Mac Addendum

Fatten Your Mac

Mac Erratum

Photo 4

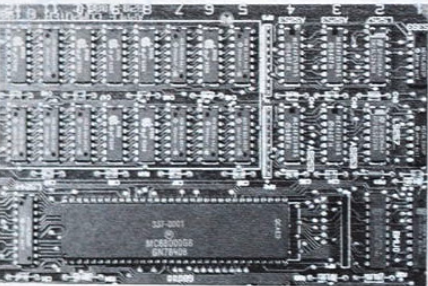
This arrived too late to make it into the "Fat Mac" article. If you have the newer 128K motherboard, when you get to page 20 you will need to follow these instructions to install the memory select logic.

- 1) Cut and remove jumper W1 (marked 128K only) located at G14 (see photo on this page)
- 2) Install and solder two 2.2K $\frac{1}{4}$ w resistors at locations R40 and R41
- 3) Install and solder a 47 ohm $\frac{1}{4}$ w resistor at location R42
- 4) Install and solder a .1uf capacitor at location C51
- 5) Install a 74AS253N IC into the socket at location G13
- 6) Check the motherboard for any solder splashes, or broken etch. Clean the board with alcohol or a TG degreaser to remove any flux left after soldering

Figure 1
Assembly Drawing

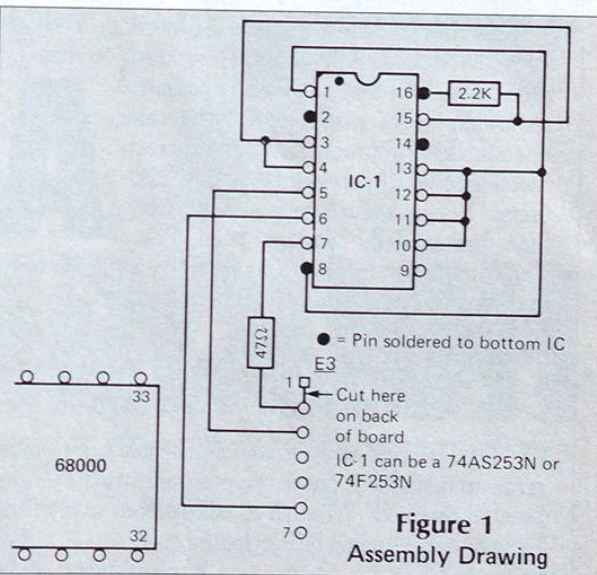
In the January Fatten Your Mac article, there is a discrepancy between the text on page 20 and Figure 1 on page 23. The figure correctly shows pin 8 soldered, but the text refers to pin 7 of the memory select IC. Readers who have called to point out the error inform us that the error in the text is obvious to anyone who works through and understands the article and the figures. We hope so.
